Access Compliance Report Public Rights-of-Way (Curb Ramps)

Main Street: PACIFIC_ST Cross Street: ROCKWELL_AVE Location: NE

ADA ID: RPRK211005172407 Ramp Type: Type 1 - Perpendicular Diagonal Initial Pass/Fail: Fail Overall Compliance: No Severity Score: 15

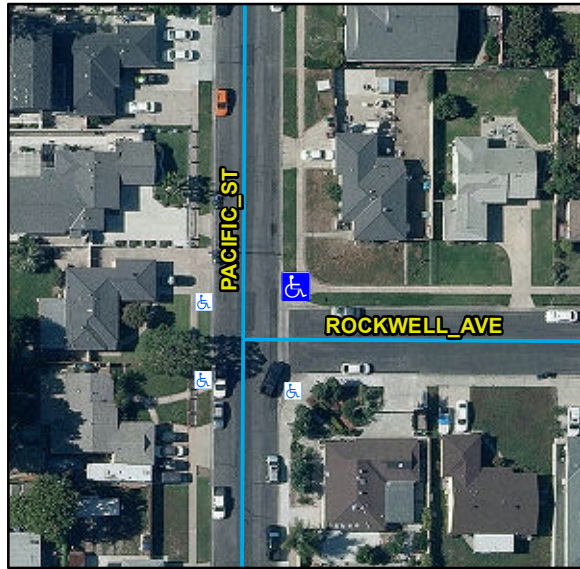
R304.2.2, STD 1115

Compliance	Description	Data	Compliance	Description	Data
N/A	Ramp Length (in)	91	N/A	Flare Type LT	
Yes	Ramp Width (in)	48			N/A
No	Ramp Run Slope (%)	11.3	N/A	Flare Slope LT (%)	N/A
Yes	Ramp Cross Slope (%)	1.3	N/A	Flare Traversable LT	N/A
N/A	Landing Present	N/A	N/A	Flare Type RT	
N/A	Landing Length (in)	N/A			N/A
N/A	Landing Width (in)	N/A	N/A	Flare Slope RT (%)	N/A
N/A	Landing Run Slope (%)	N/A	N/A	Flare Traversable RT	N/A
N/A	Landing Cross Slope (%)	N/A	N/A	DWS Provided	N/A
N/A	Landing Movement Obstructed?	N/A	N/A	DWS Contrast	N/A
	Landing Movement Type	N/A	N/A	DWS Length (in)	N/A
N/A	Landing Shared	N/A	N/A	DWS Full Width	N/A
N/A	Clear Space	Yes	N/A	DWS Offset Left (in)	N/A
N/A	Clear Space To Crosswalk (in)	N/A	N/A	DWS Offset Right (in)	N/A
N/A	Marked Crosswalk 1	No	N/A	Marked Crosswalk 2	No
	Crossing 1 Direction	W		Crossing 2 Direction	S
	Marked Crosswalk 1 Width (in)	N/A		Marked Crosswalk 2 Width (in)	N/A

Remove & Replace Curb Ramp With Two New Directional Ramps or Equivalent.
